Appendix 3: Supporting Technical Report

To: Selwyn District Council
From: Hugh Nicholson, Urban Designer
Date: 12 October 2022
Re: DPR-0209 Lincoln Rezoning Request for Proposed Selwyn District Plan
Urban Design and Landscape Review

Figure 1: Lincoln Structure Plan 2008 with site outlined in red

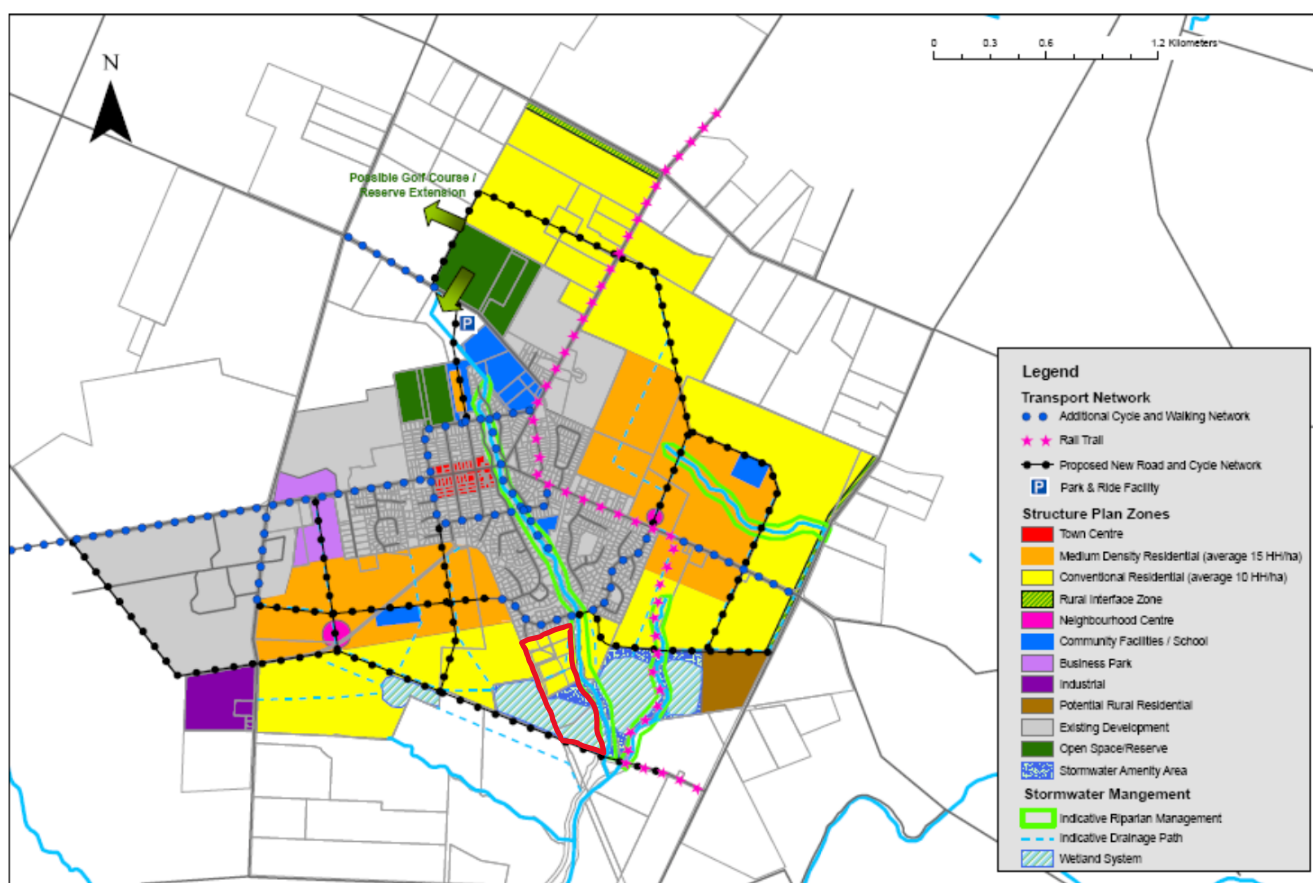
2.11 The **Lincoln Structure Plan** (adopted in 2008) identifies the northern half of the site for conventional residential development and the southern half for a stormwater management wetland system (see Figure 1)¹².

Figure 2: Impact of Odour Control Setbacks on possible development

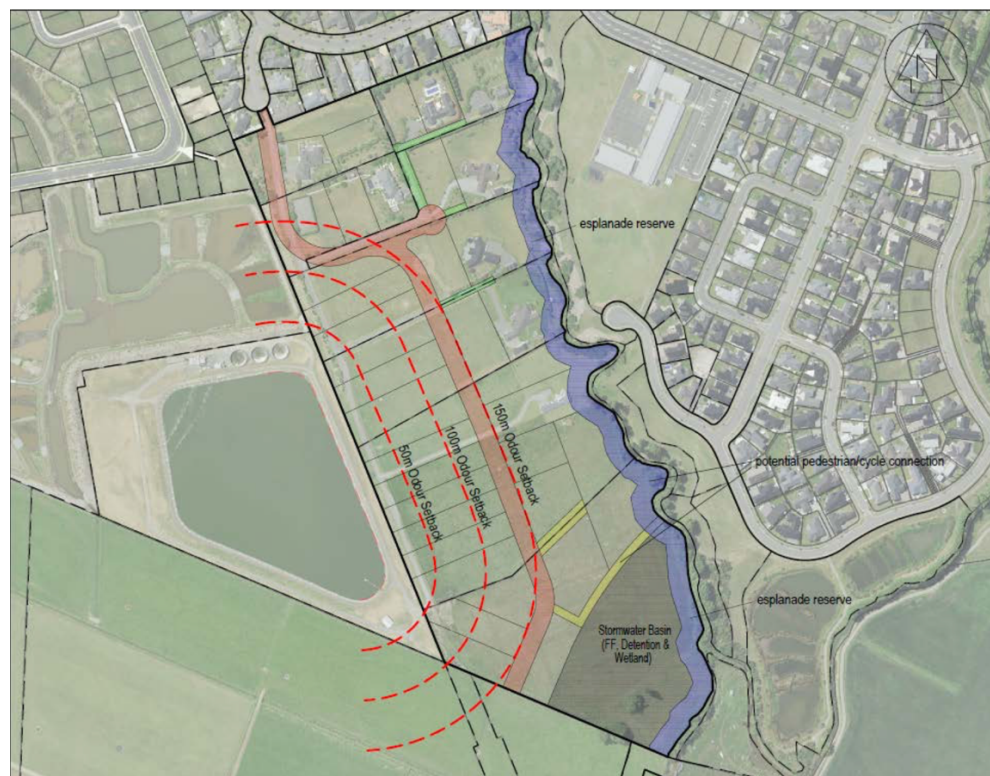
- 3.3 The size of the odour control setback from the Lincoln Wastewater Treatment plant would affect the capacity of the site for development.
